Duke Power Company
Oconee Nuclear Station

Proposed Technical Specification Revision
Oconee 2, Cycle 9

No Significant Hazards Consideration Evaluation
for Oconee Unit 2, Cycle 9 Reload

Startup Physics Test Program Revisions

OPERATIONAL POWER
IMBALANCE ENVELOPE
FROM 0 EFPD TO EOC
UNIT 2

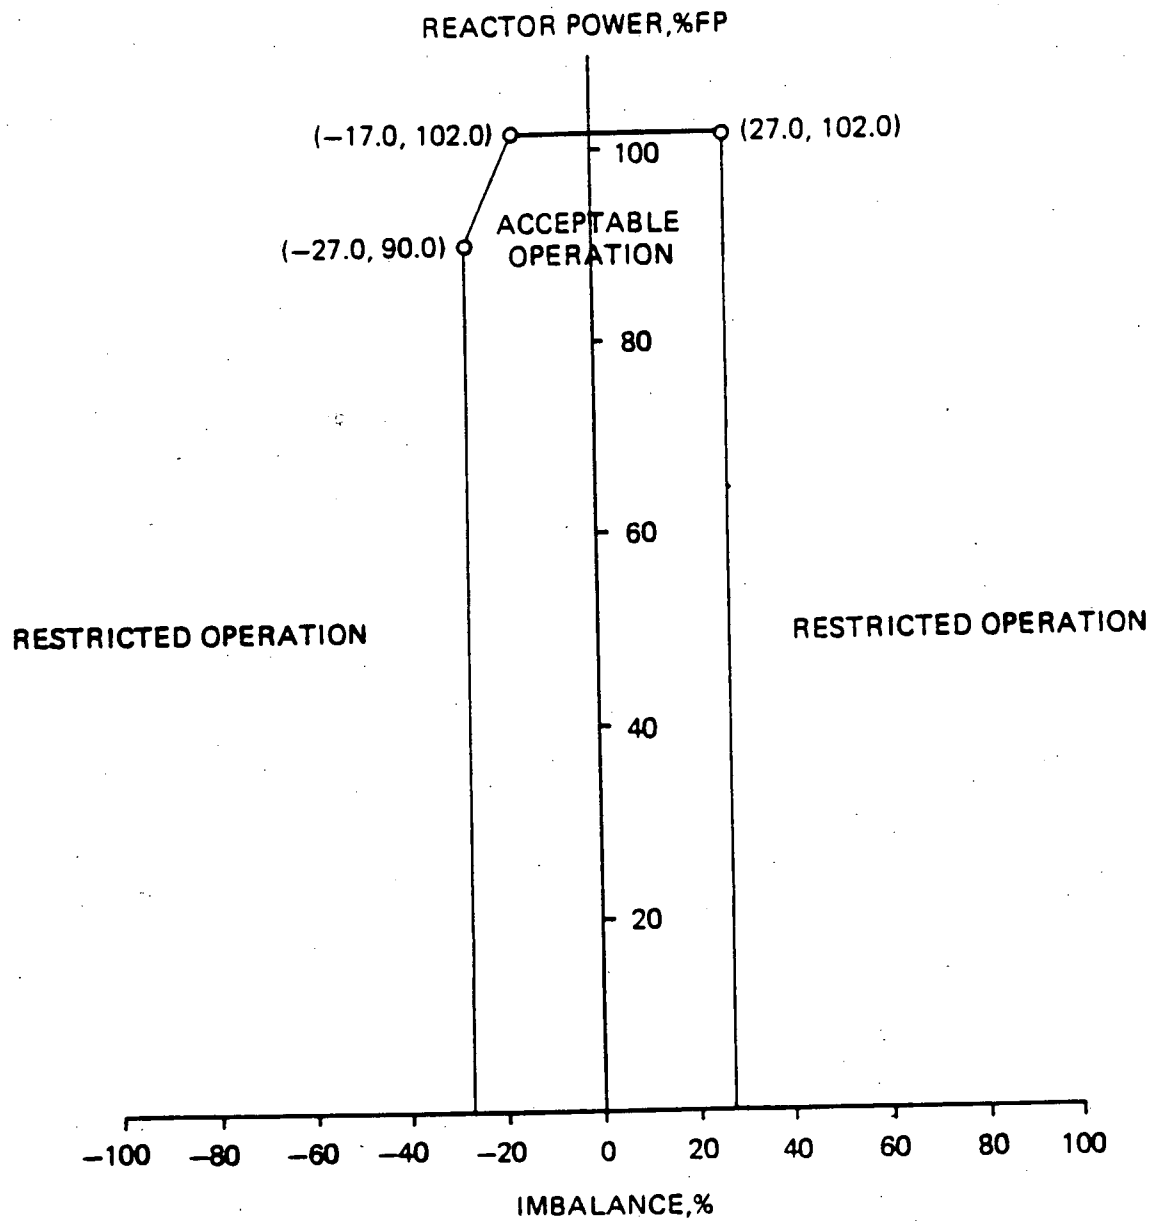
Remove Page

3.5-25

Insert Page

3.5-25
